**From:** Edward Kisiel <EKisiel@HNTB.com>  
**Sent:** Thursday, November 10, 2011 3:04 PM  
**To:** 'Maddern, Rodger A.'  
**Cc:** 'Hedrick, Mark'; Malone, Curtice; Gibson, Ornette; 'utilities@ohio.net'; Kenneth Fertal; kishmael@hntb.com  
**Subject:** Cleveland Innerbelt - Commercial Rd (at Central Viaduct - south) - IntelliFiber  
**Attachments:** 2011-11-10 - RoadwayGateway-Commercial-Parking.pdf

ROADWAY  
 GATEWAY

PARKING LOT PLAN  
GRADING  
DOWNTOWN NEIGHBORHOOD PARKING

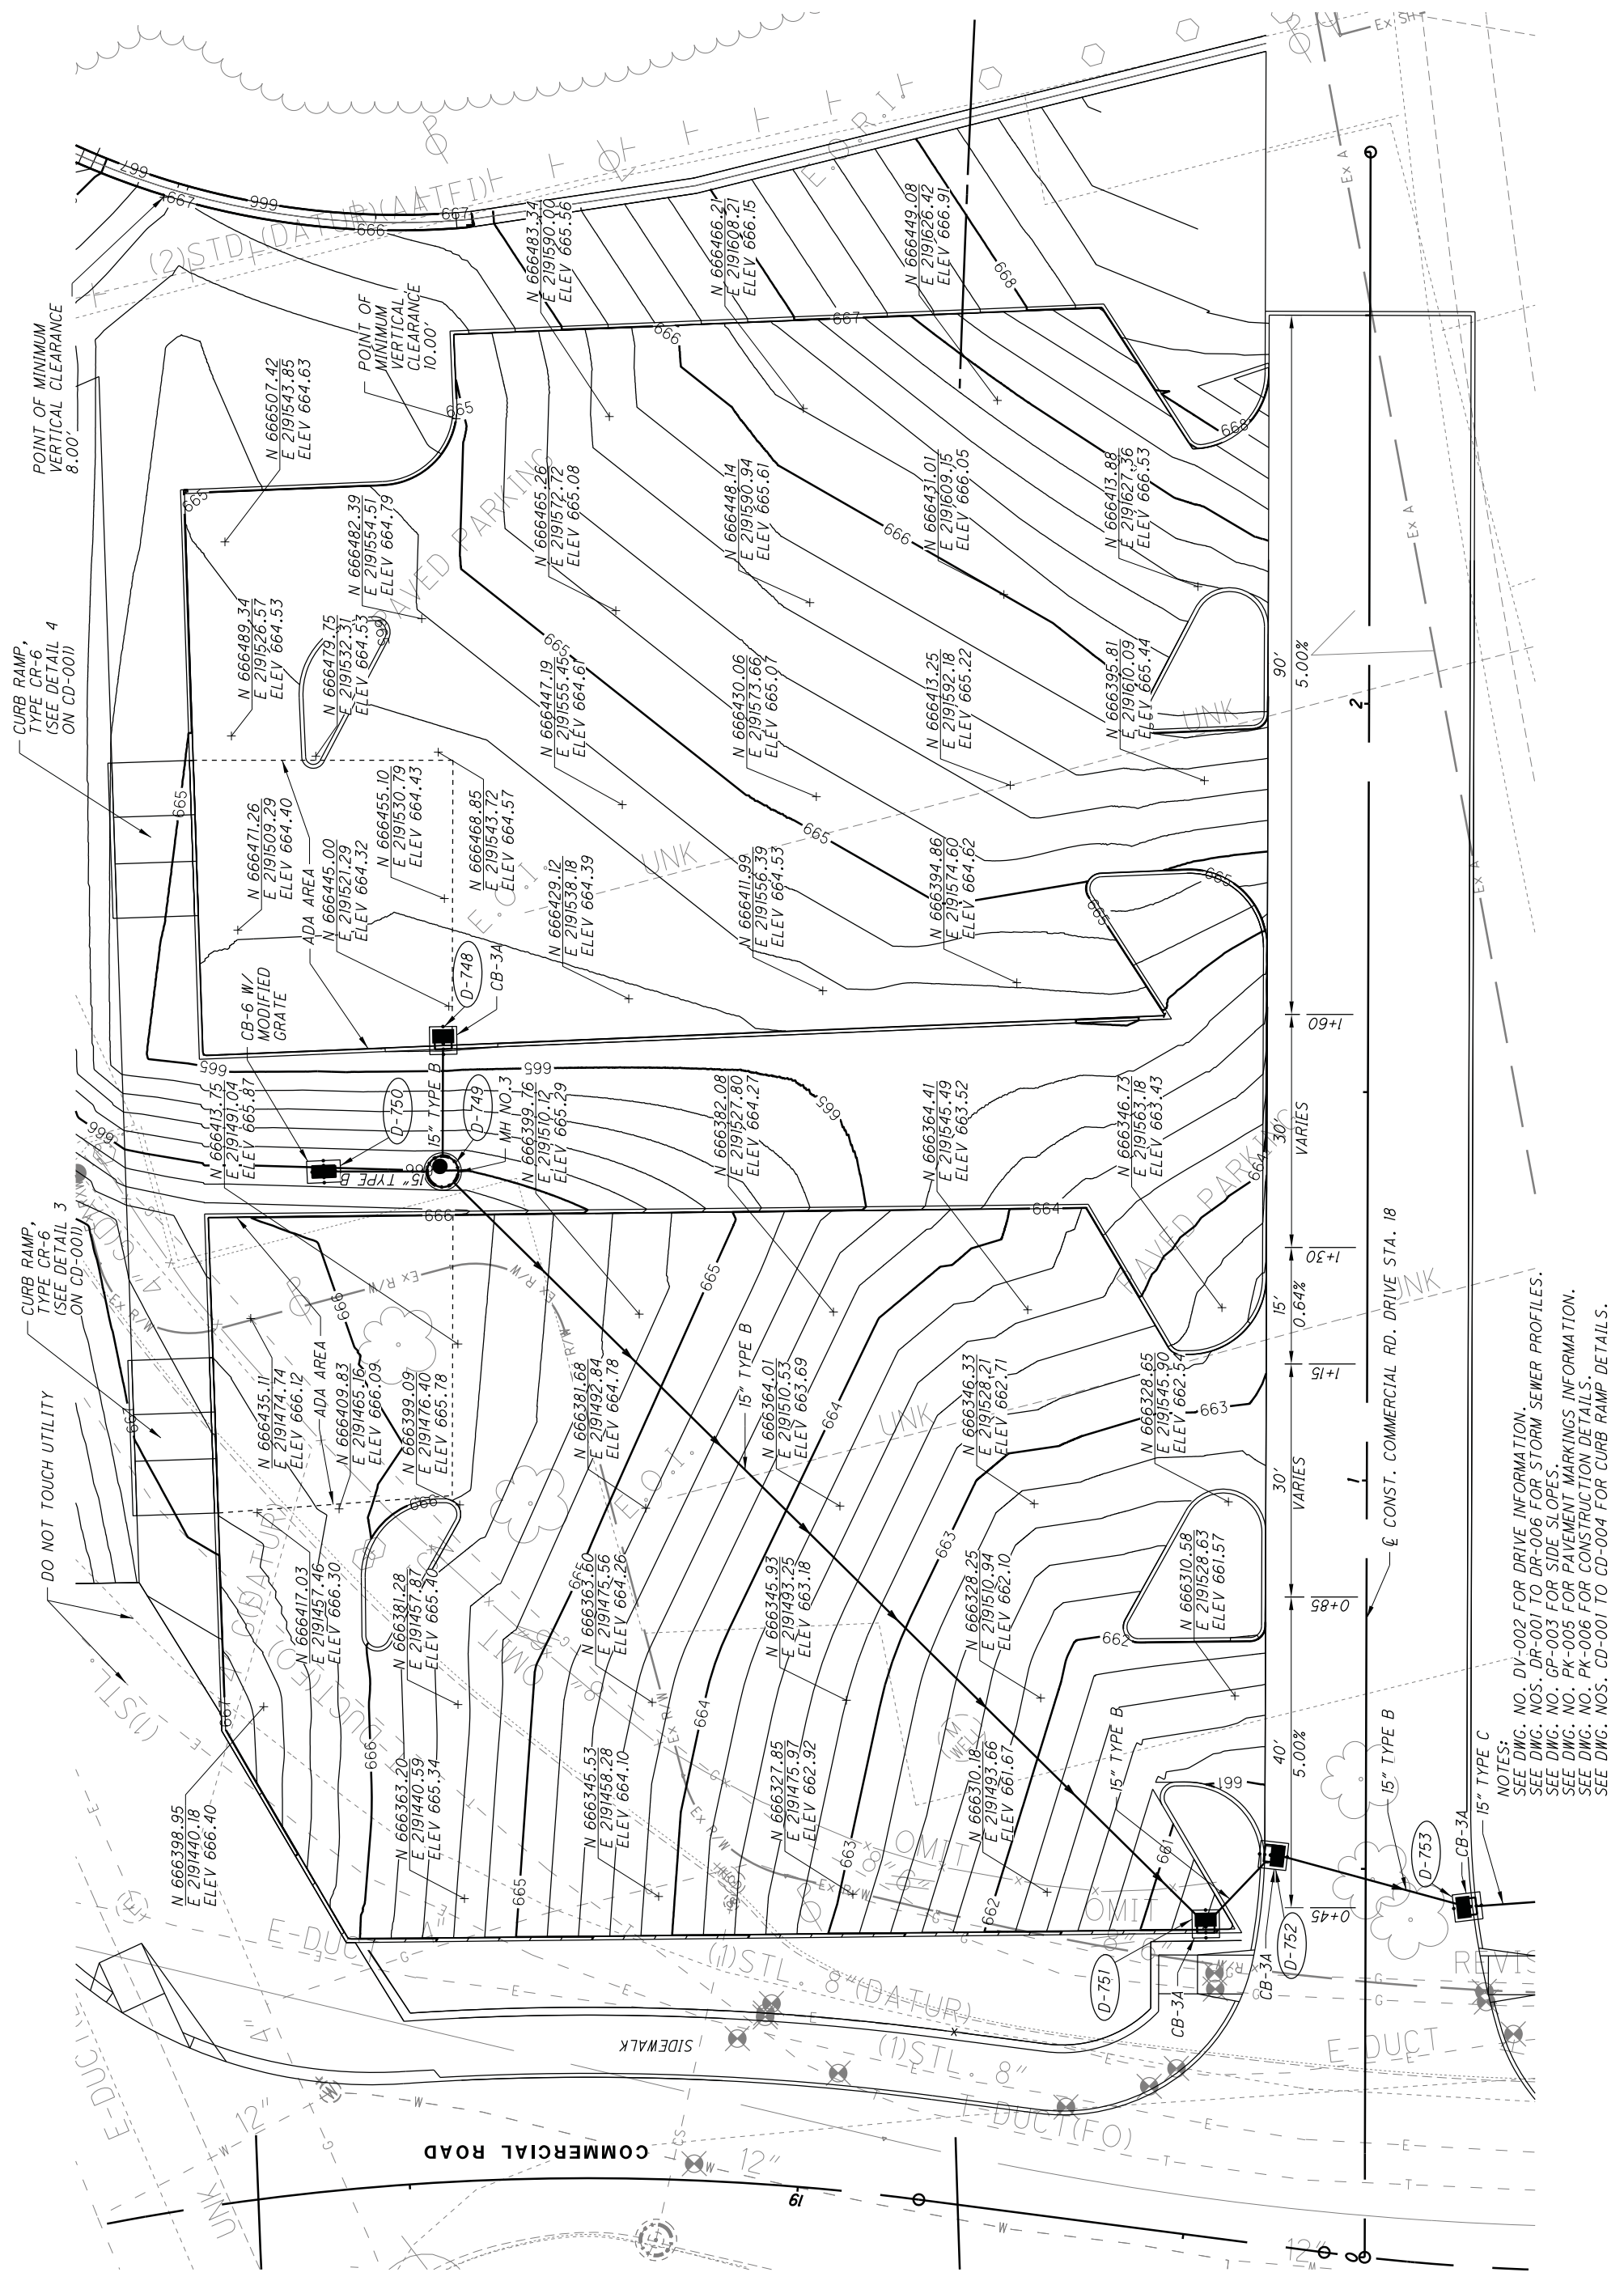
After our discussions in the field last Thursday, 11/03 about IntelliFiber duct run, I made a call to Rick Colello and he confirmed ducts were built approx. having depth of cover at 36" requiring your duct run to be lowered (as we discussed) through the Gateway parking lot, see attached PDF. Not much can be done about raising or adjusting parking lot grading to mitigate since the slope is maxed out. Also noticed clearance might be getting tight on Commercial Rd. (I can provide more data on this if needed).
